Subject: AP1000 COL Standard Technical Report Submittal of APP-GW-GLR-127, Revision 0

“PCS Tier 1 Diagram Correction”

PCS Tier 1 Diagram Correction

Figure 2.2.2-1
Passive Containment Cooling System

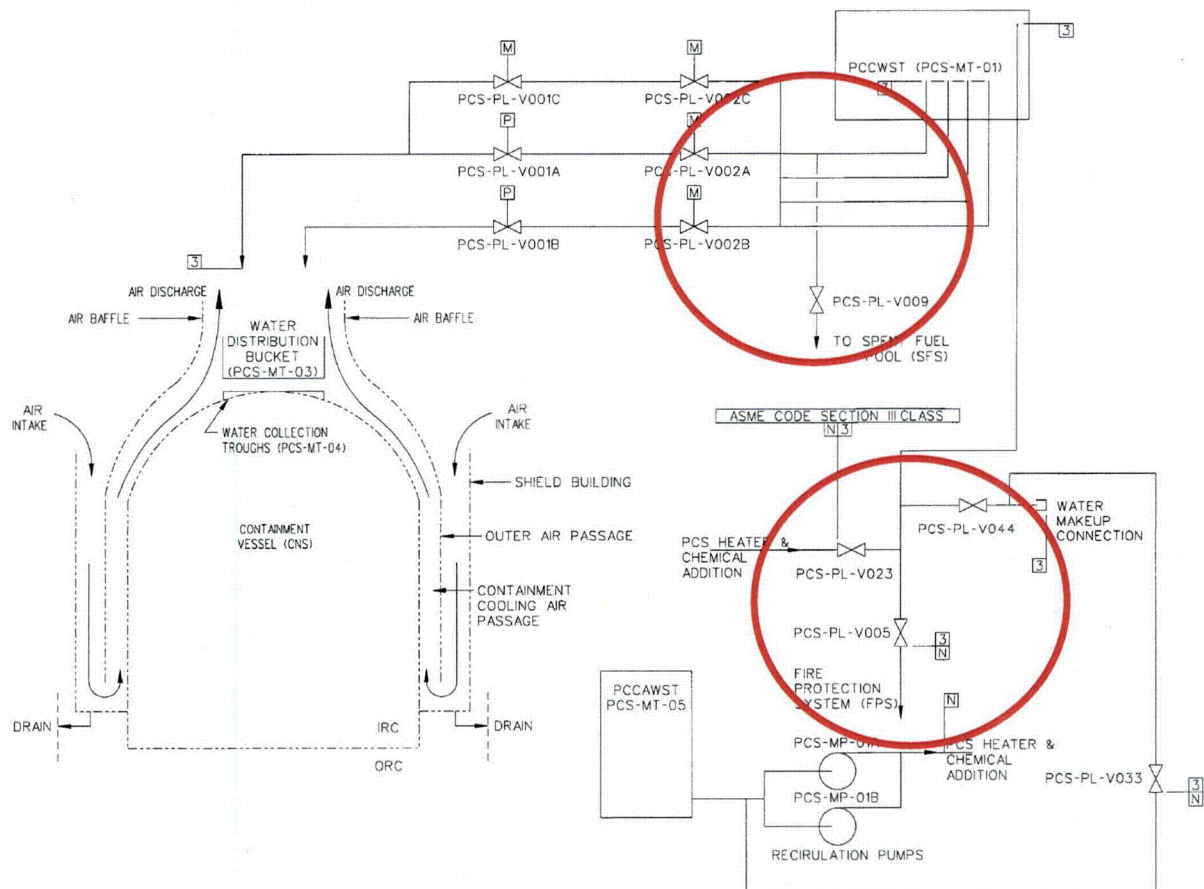
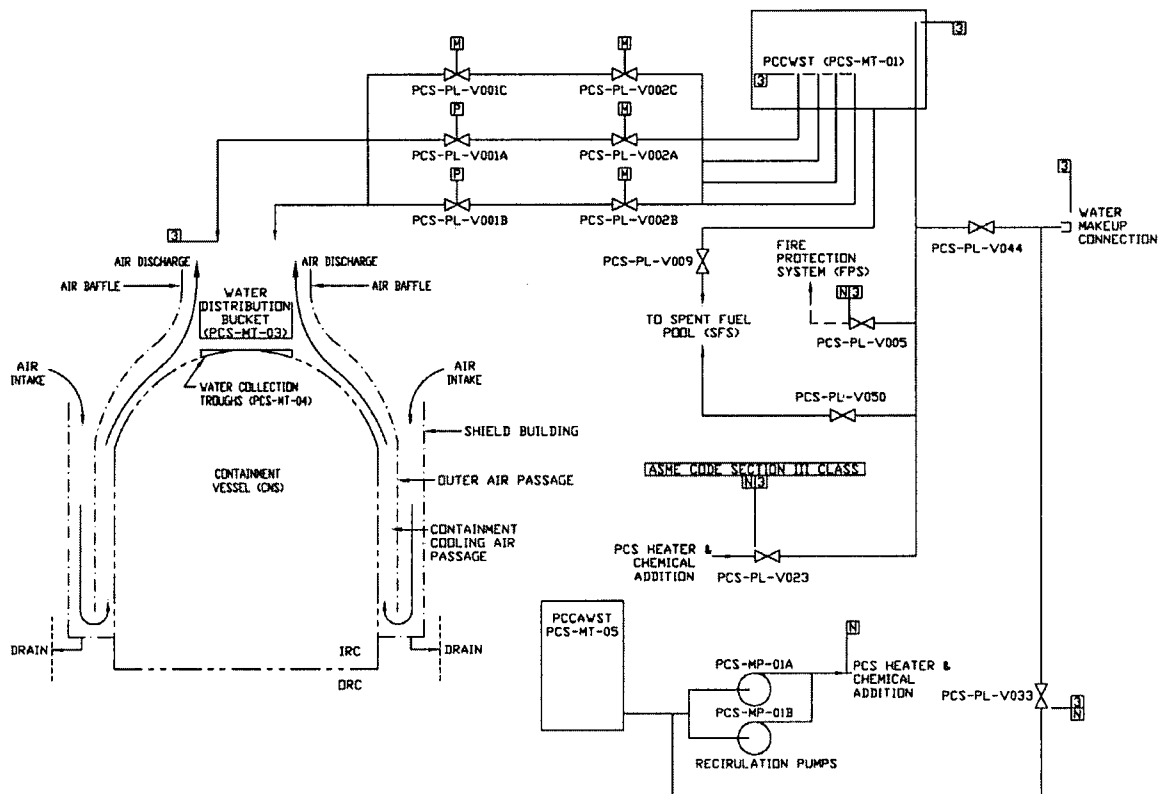
The changes discussed in this report were covered in AP1000 document APP-GW-GLN-019 (Reference 3). The Tier 1 impacts of these changes are addressed in this technical report. There are three corrections made to the figure 2.2.2-1. They are as follows:

1. The line leading from the PCCWST to the spent fuel pool (including valve V009) no longer branches off of the standpipe in the tank. This line now has its own connection into the tank (Reference 3).
2. Downstream of the pumps, heater and chemical addition tank the connection to the Fire Protection System has been moved to reflect where it exists in the design. This was a correction that was made to the PCS P&ID to match the current design (Reference 3).
3. Valve V050 is added to the Tier 1 diagram. This valve has always been present in the design. It is now included in the Tier 1 figure to address the following commitment made in the Tier 1 text:

The PCS delivers water from the PCCAWST to the PCCWST and spent fuel pool simultaneously.
